Official Transcript of Proceedings
NUCLEAR REGULATORY COMMISSION

Title: Advisory Committee on Reactor Safeguards
Plant License Renewal Subcommittee

Date: Wednesday, January 12, 2011

14 This Subcommittee will review the license
15 renewal application for the Crystal River Unit 3
16 Nuclear Generating Plant and the associated Safety
17 Evaluation Report with open and confirmatory items.

SGR OPENING SEQUENCE & IDENTIFICATION OF DELAMINATION

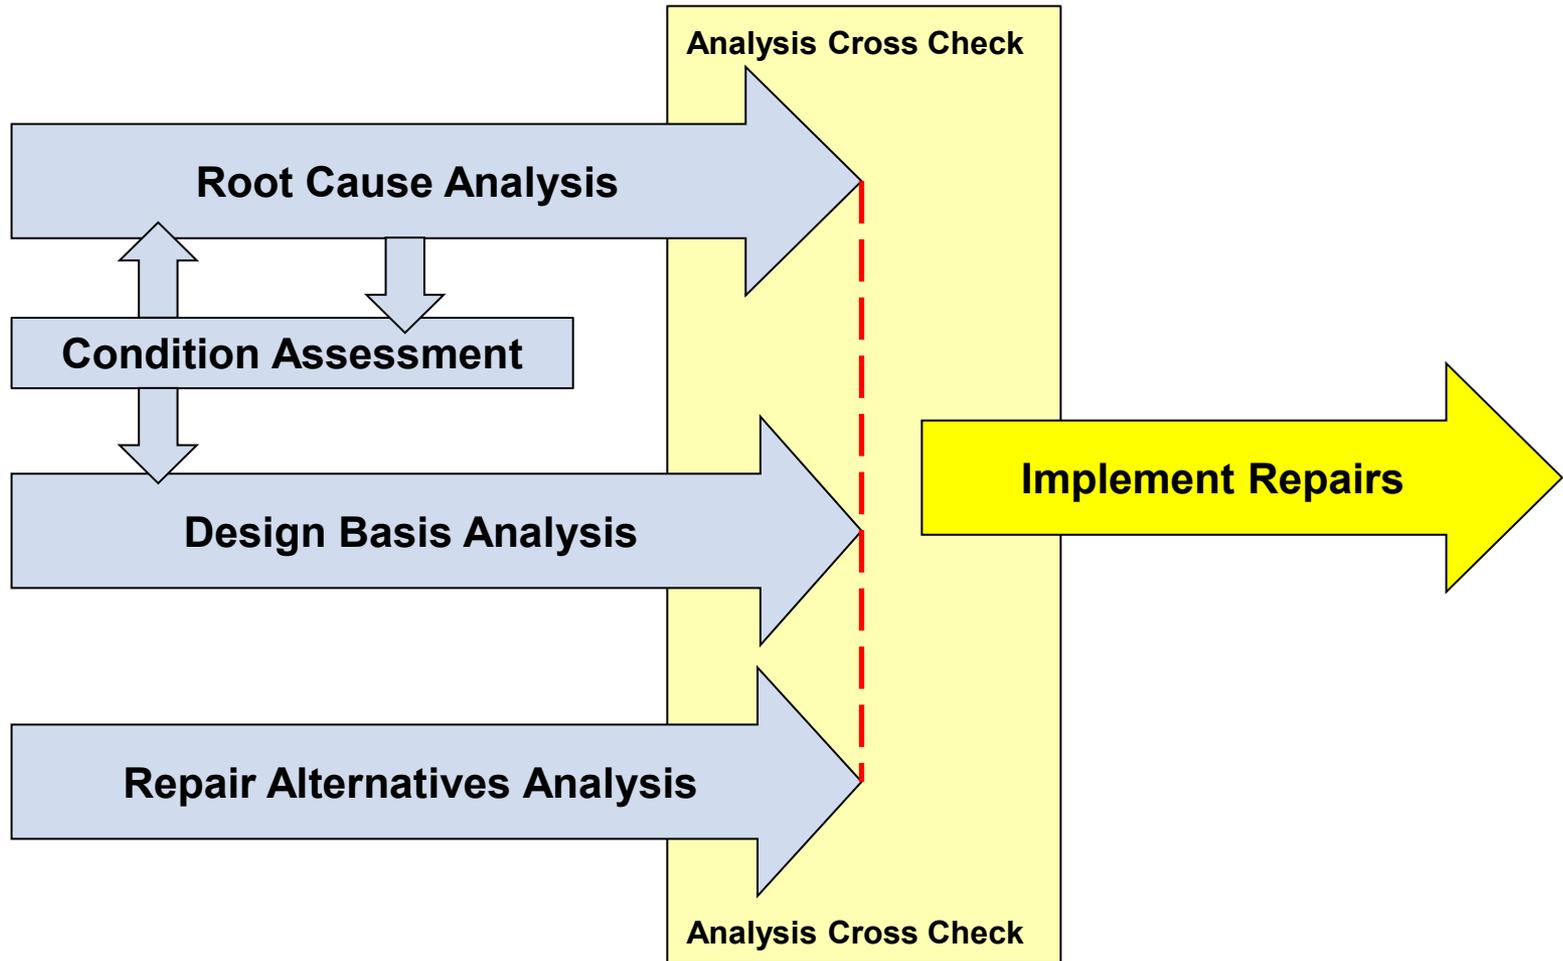
4 This graphic does depict the tendon sleeve
5 so as you can see these are horizontal tendons which
6 run in pairs and then you can see a little deeper in
7 on the inside plane of those is where the vertical
8 tendons run.

9 I'd also like to point out, note that
10 there is a complete lack of reinforcement inside the
11 plane of the tendons. There is no structural rebar in
12 that plane inside of the tendons.

13 There are a set of outer map rebar, number
14 8 bars that were part of the original design, mostly
15 just to resist thermal cracking, though they're small
16 bars, number 8s and that was just on the outside plane
17 beyond the tendons.

18 The delamination is depicted there. It is
19 the red line. You can see it and it is run
20 consistently in the plane of the horizontal hoop
21 tendon, so it's nominally about 9 to 10 inches deep
22 from the outside of containment.

Final Reinforcement Installation

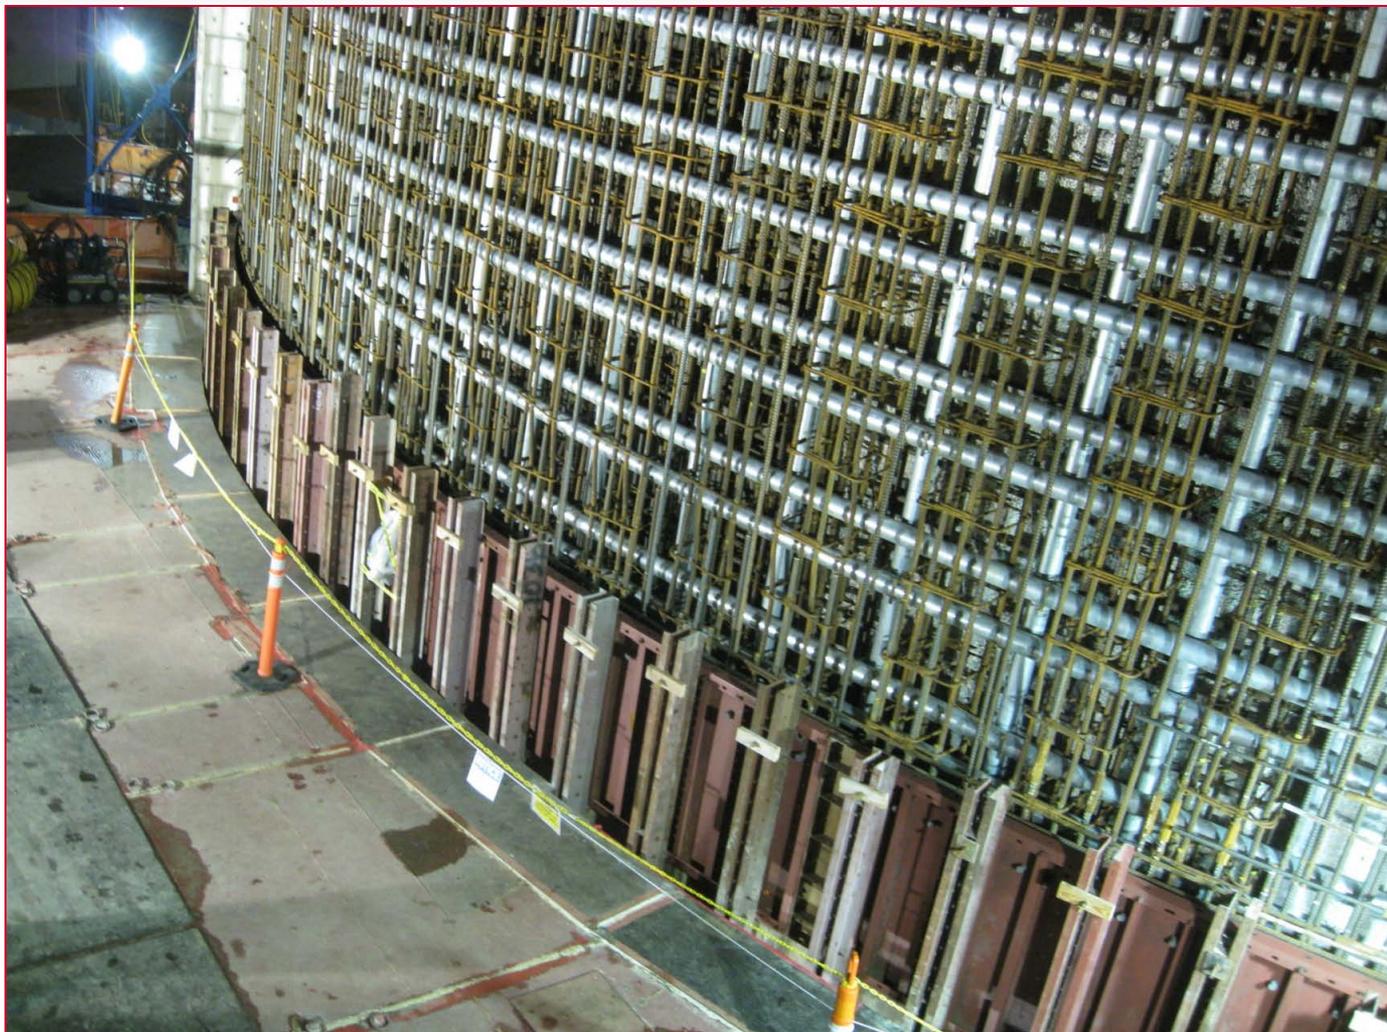
14 CHAIRMAN SIEBER: I saw the slides.
15 That's why I asked the question. It looked like more
16 rebar than I'm used to seeing in a post-tension
17 containment under construction. So my question again
18 is is the rebar design in other pictures in the
19 section that you replaced different than the original
20 design?

1 in the slides was more like standard containment, as
2 far as rebar density and spacing is concerned as
3 opposed to my memory of what post-tension containments
4 look like in their skeletal structure. Is that a
5 correct impression?

5 MR. CAHILL: We used another vendor, MPR,
6 is one we relied on heavily to do analysis for that
7 looking at -- really literally now we'll have a much
8 stiffer Bay 3-4 because of the amount of reinforcement
9 it has there with a significant amount of new
10 concrete. So we did look on the effects of adjacent
11 bays, on our liner. We have several formal
12 engineering analyses and calculations that the staff
13 has reviewed in detail. We've had a lot of
14 interactions with Meena's civil staff on each of those
15 individual changes and looking at the technical
16 validity of each of those going back to what our
17 original design basis was to make sure that it wasn't
18 invalidated.

19 So yes, it is a big change from that
20 perspective because the other bays don't have that
21 level of reinforcement. But we did a lot of
22 engineering work to support that.

Impacts on the Containment Liner

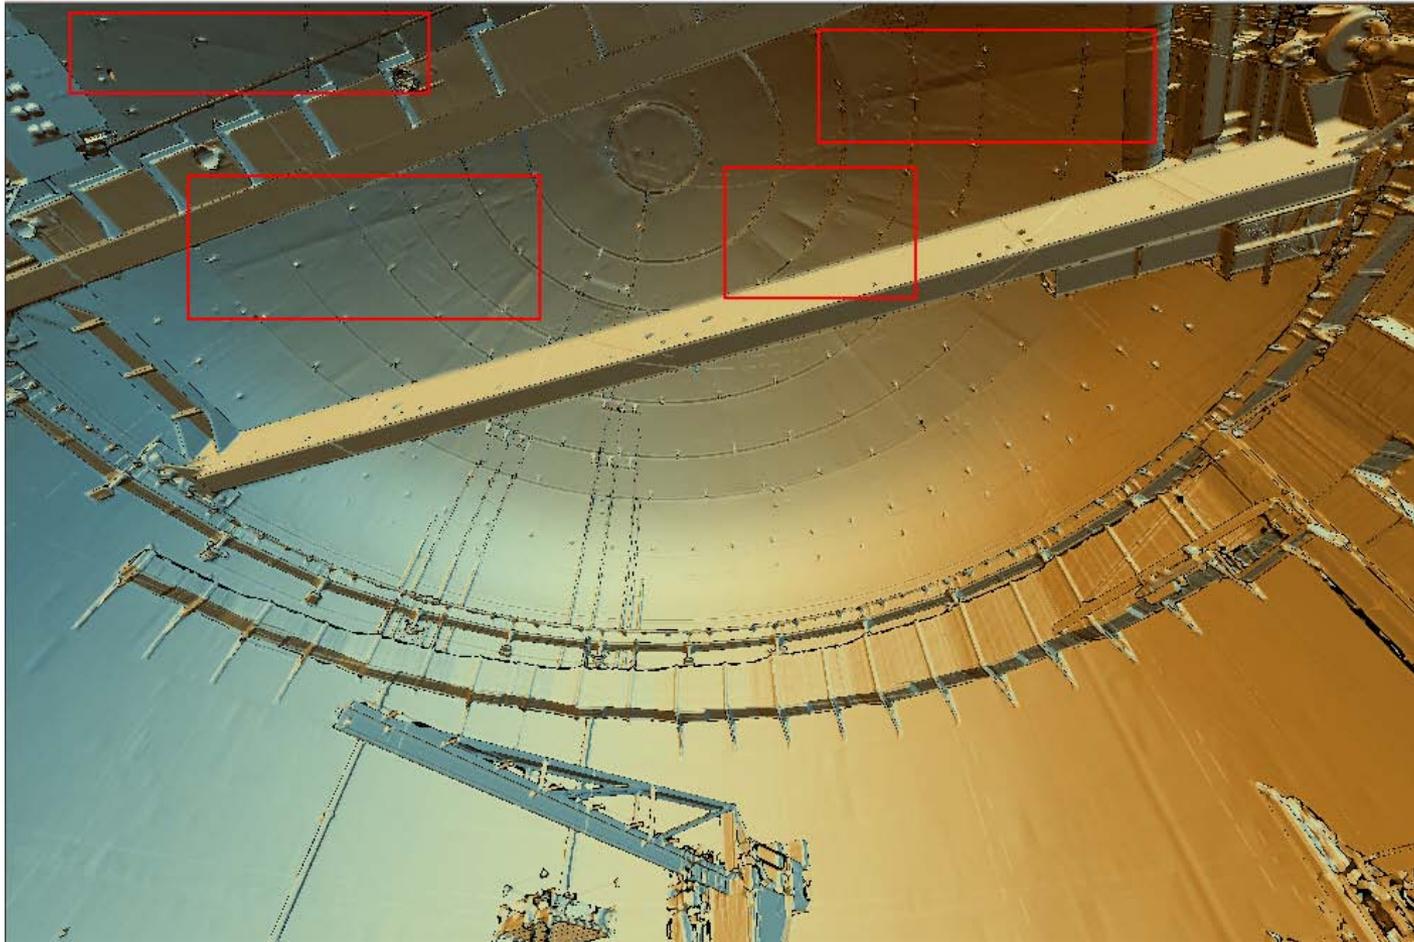
4 MR. BARTON: While we're taking this
5 break, the question on -- you've had some areas of
6 your liner where you've got bulges. Where this liner
7 is exposed in this one photograph, on the inside of
8 that liner in that area, are any of the bulges that
9 you found in that area?

- Design impacts on the Containment liner due to the repair have been evaluated.
- The results of the calculations show that there is no impact on the current design basis of the Containment liner.
